Version 3

Emissions Recall: 2023 CR-V Hybrid Short Block Manufacturing Inspection

Supersedes Version 2 to revise the information at:

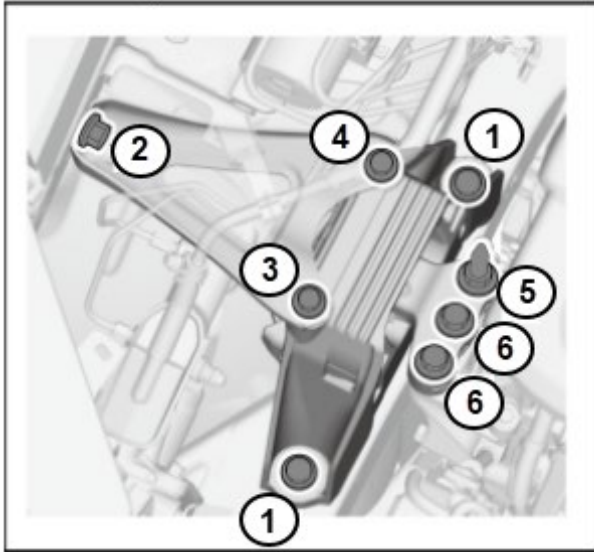
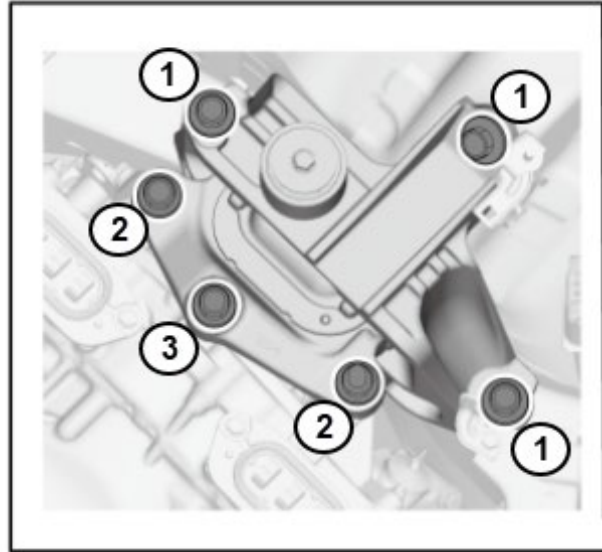
Under REPAIR PROCEDURE, step 51 was revised with new image.

51. With the lift table supporting the engine, unbolt the side engine mount from the engine and the transmission mount.
